AN ORDINANCE AMENDING CHAPTER 106 OF THE CODE OF ORDINANCES, THE CITY OF SHREVEPORT ZONING ORDINANCE, BY REZONING PROPERTY LOCATED ON THE EAST SIDE OF VIKING DRIVE APPROXIMATELY 760 FEET NORTH OF EAST OLIVE, SHREVEPORT, CADDO PARISH, LA, FROM R-1H, URBAN ONE FAMILY RESIDENCE DISTRICT TO B-1 BUFFER BUSINESS DISTRICT WITH SITE PLAN APPROVAL, AND TO OTHERWISE PROVIDE WITH RESPECT THERETO

C-2-15
SPAR – Valencia Park

METROPOLITAN PLANNING COMMISSION
STAFF REPORT - February 4, 2015

CASE NO. C-2-15: ZONING REQUEST AND USE APPROVAL WITH SITE PLAN

PROPOSED SITE PLAN

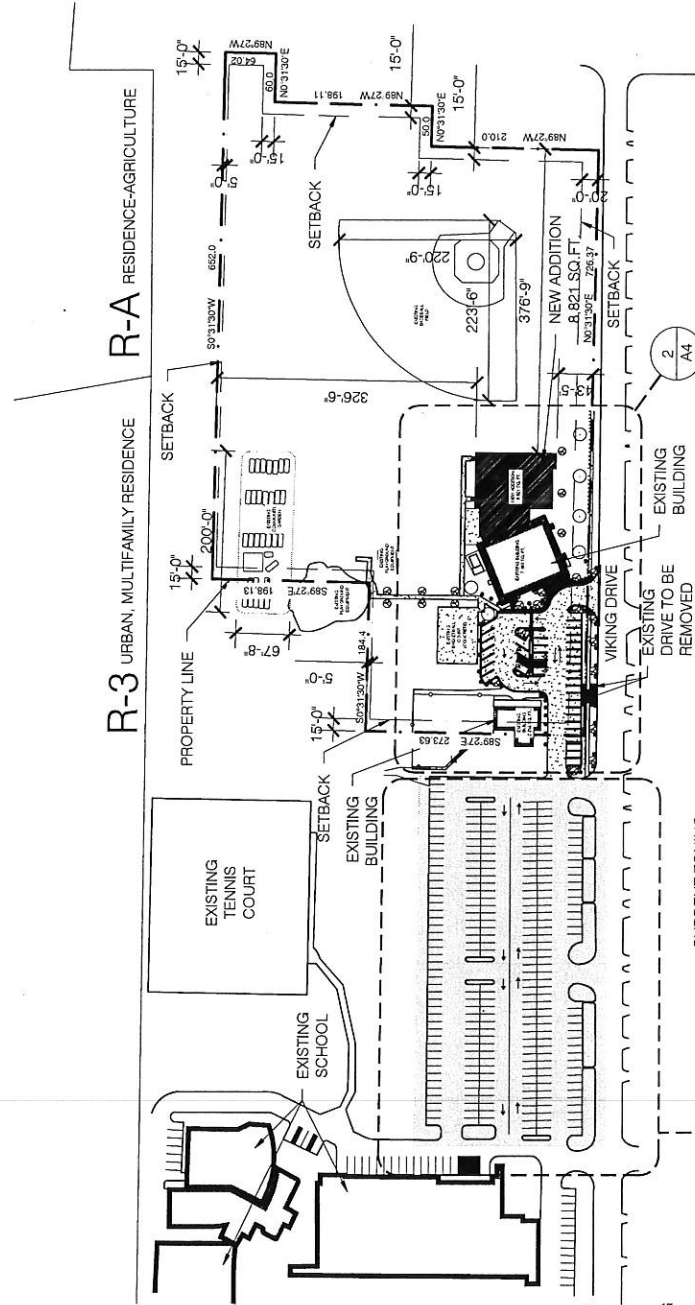
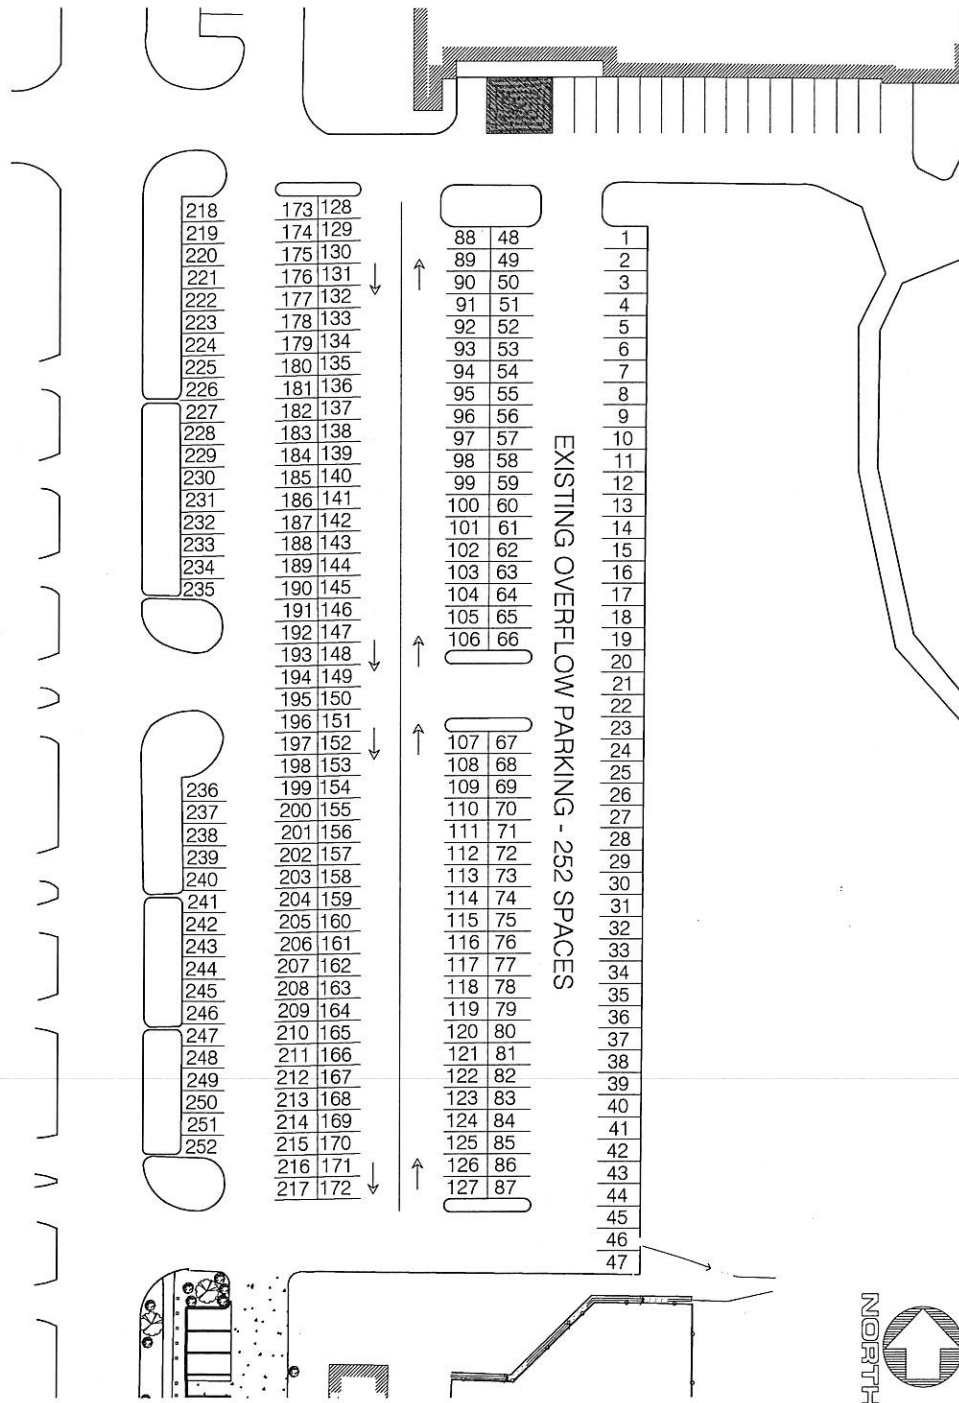
- SPAR has its own dump truck that picks up trash once a week. We requested that a small area enclosed by a solid wood fence containing enough space for two or three refuse containers be indicated on the site plan. No clear indication of this feature can be found on the site plan.

- There is a curb cut (driveway) indicated along Viking Drive that terminates into parking spaces. This driveway will be removed.
- The site plan indicates 36 parking spaces that are contained within the boundary of the property owned and controlled by the City of Shreveport. However, the 252 parking spaces owned and operated by the School District have been utilized for overflow parking for decades. The applicant has indicated their desire to enter into a formal agreement with the Caddo Parish School District, but have not yet had the opportunity to formalize those agreements. SPAR has obtained formal approval for shared access of driveways that facilitate the use of the parking lot, but a formal agreement has not been obtained.

- All enclosed structures contained within this site (including new additions) total 16,978 Square Feet. All outdoor uses total 36,912 Square Feet.
- The architect of record has indicated on the plans submitted that 170 parking spaces are required. However, the exact use as described by the applicant does not have a parking ratio defined in the zoning ordinance. The ordinance requires that the Zoning Administrator make a determination of need if the use is not specifically listed in the required parking table. **The determination is that the indoor use will require one parking space for every 500 square feet of gross floor area and one parking space for every 1,000 square feet for the outdoor recreational uses.** These ratios are commonly excepted ratios based on current best practices in zoning ordinances nation-wide. **Based on the ratios described above, the parking requirement would be a total of 72 parking spaces. Leaving a deficit of 36 parking spaces.**

- Storm Water detention is not indicated on the site plan. The applicant has indicated that the engineer of record for this project is currently preparing the final plans. In conversations with the City Engineers office, we have determined that only the new storm water run-off generated by the introduction of impervious surface associated with the new construction will be required to be accommodated in the plan.

- A revised site plan shall be submitted to and approved by the Executive Director that indicates the following:
 - The location of an area enclosed by a six foot high solid wood fence containing enough space for two or three refuse containers.

- The location and description of any improvements that will manage storm water detention including above ground basins or subsurface detention systems.

- Indicate all property boundaries modified by the requested plat of the property on the site plan with dimensions that clearly demonstrate that all building improvements are in compliance with building setback requirements.
